Docket Nos. 50-237  
50-254

Commonwealth Edison Company  
ATTN: Mr. J. S. Abel  
Nuclear Licensing Administrator -  
Boiling Water Reactors  
Post Office Box 767  
Chicago, Illinois 60690

The enclosure to this letter identifies information that we require to complete our review of the ECCS reanalysis you will submit pursuant to our Order for Modification of License dated December 27, 1974. Some of the information has previously been identified (e.g., single failure analysis), but has been repeated here for completeness.

Enclosure:  
Required Information  
(ECCS)

Figure 1  
Area of Steel Heat Sinks Inside Containment

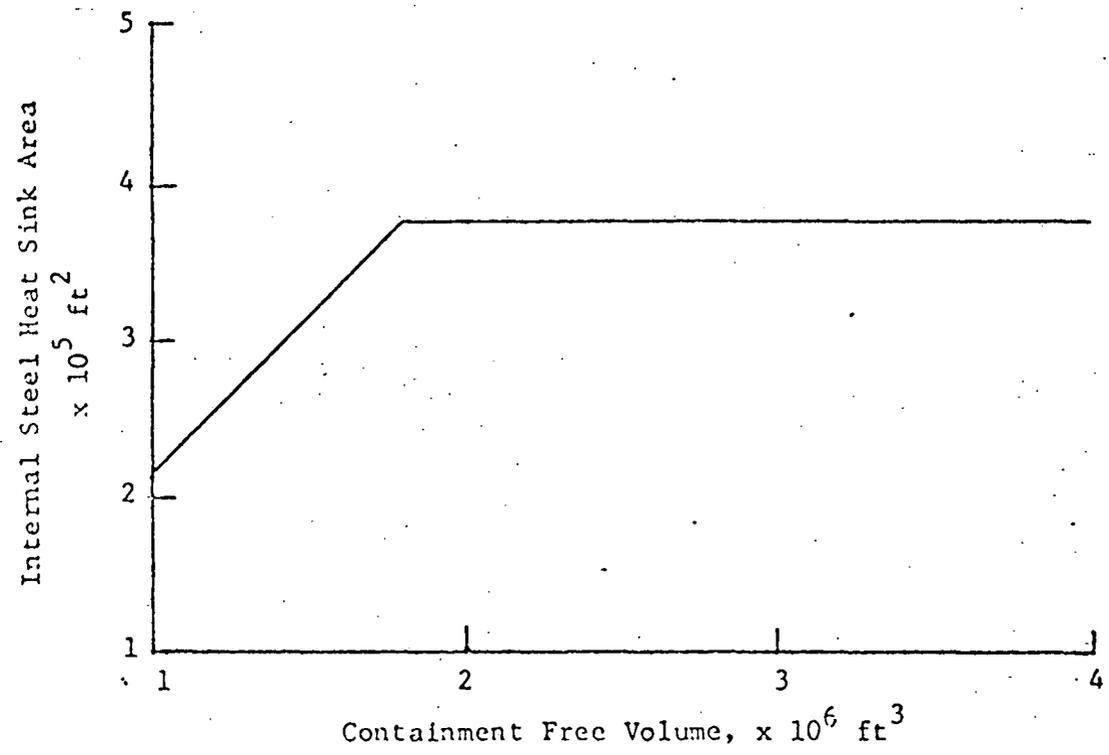
- (1) Use the surface area and thickness of the primary containment steel shell or steel liner and associated anchors and concrete, as appropriate.
- (2) Estimate the exposed surface area of other steel heat sinks in accordance with Figure 1 and assume an average thickness of 3/8 inch.
- (3) Model the internal concrete structures as a slab with a thickness of 1 foot and exposed surface of 160,000 ft<sup>2</sup>.
